PREVOST

WARRANTY BULLETIN

WB23-16A

DATE :	November 2023	SECTION :	06 ELECTRICAL
EXPIRATION:	November 2025		
SUBJECT :	SOLUTION FOR BATTERY DRAIN ON VEHICLE NOT EQUIPED WITH A PREHEATER

Figure 1: H3-45 Harness location

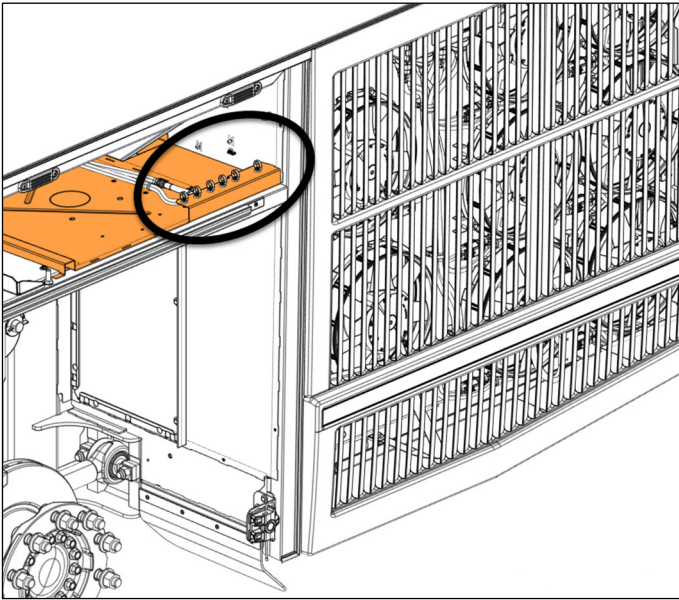
1. Locate the connector on the vehicle harness: refer to **figure 1** or **figure 2**

2. Unplug connector CSX1 and CSX3

3. On connector CSX1 install cap 564069. On connector CSX3 install cap 564660.

4. Secure harness with cable ties 504637 (4x).
